भारत सरकार
Government of India
विद्युत मंत्रालय
Ministry of Power
उत्तर क्षेत्रीय विद्युत समिति
Northern Regional Power Committee

Subject: Minutes for 59th Protection Sub-Committee Meeting.

59th Protection Sub-Committee Meeting (23rd April, 2025)-MoM

Minutes of
59th Meeting of Protection Sub-Committee (PSC) of
Northern Regional Power Committee

DR of 220 KV Baghpat(PG) (end)-Baraut(UP) (UP) Ckt-1

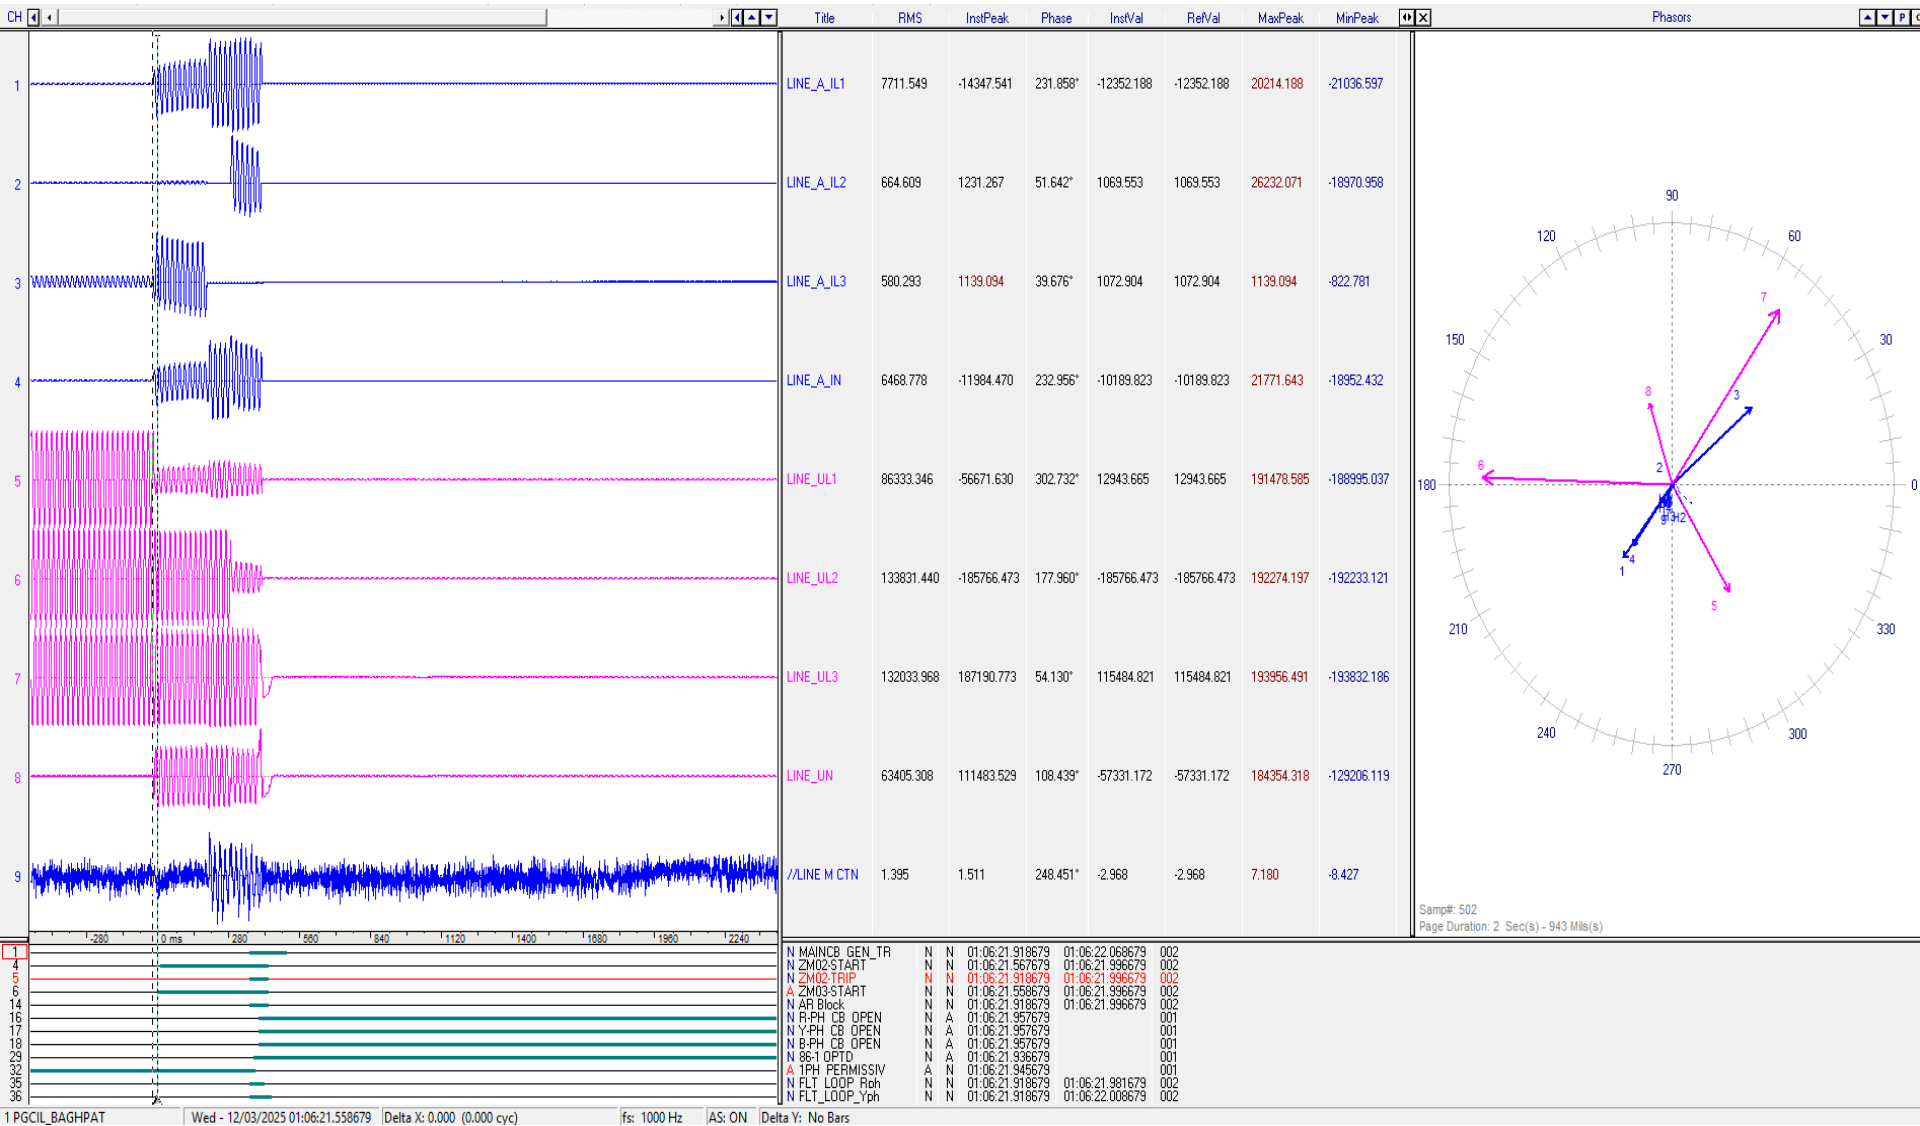
- ✓ R-N fault ($I_r \sim 7.71\text{kA}$) converted to R-Y-N fault ($I_r \sim 14.48\text{kA}$, $I_y \sim 15.87\text{kA}$)
- ✓ Fault cleared in zone-2 from Baghpat(PG) end
- ✓ Fault clearing time $\sim 440\text{ms}$

DR of 220 KV Baghpat(PG) (end)-Baraut(UP) (UP) Ckt-2

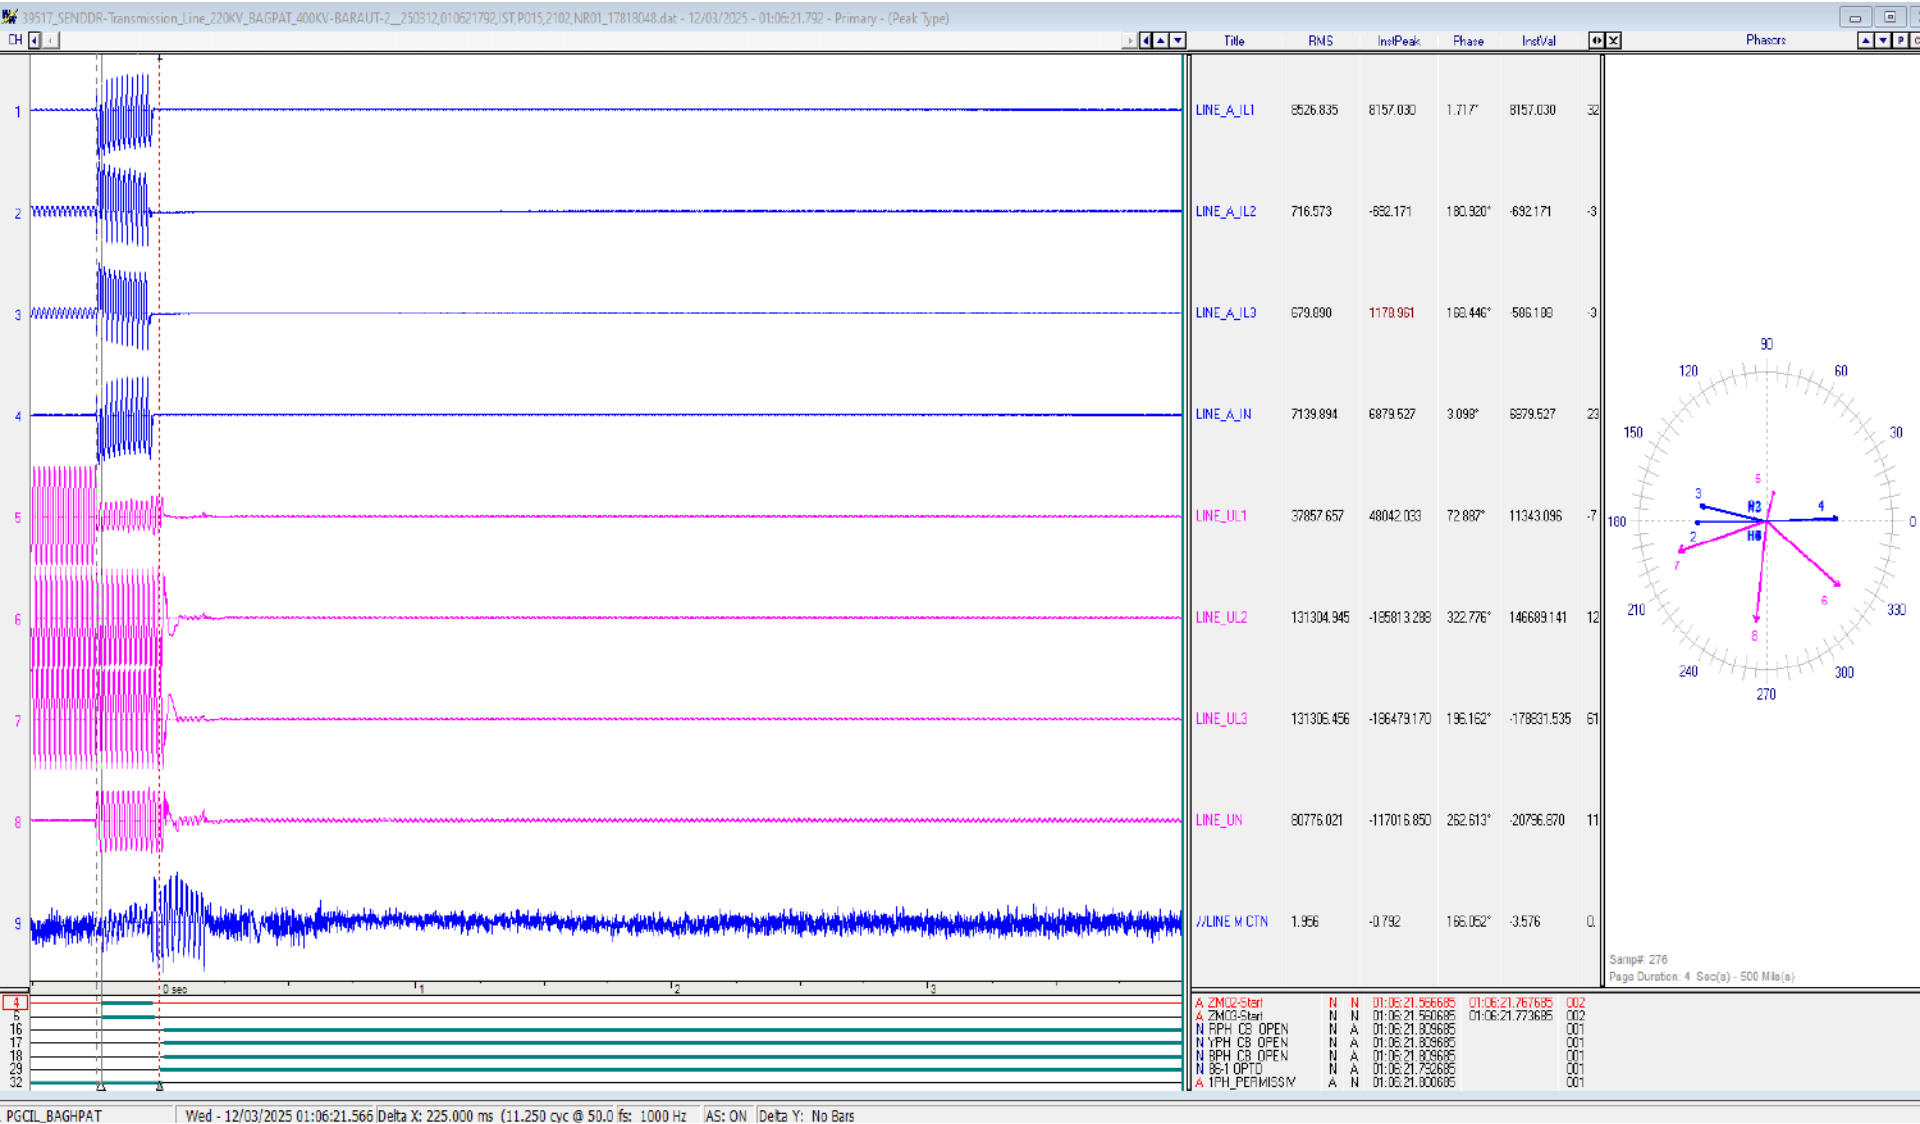
- ✓ R-N fault ($I_r \sim 8.53\text{kA}$)
- ✓ Fault sensed in zone-2 at Baghpat(PG) end
- ✓ Fault clearing time $\sim 240\text{ms}$
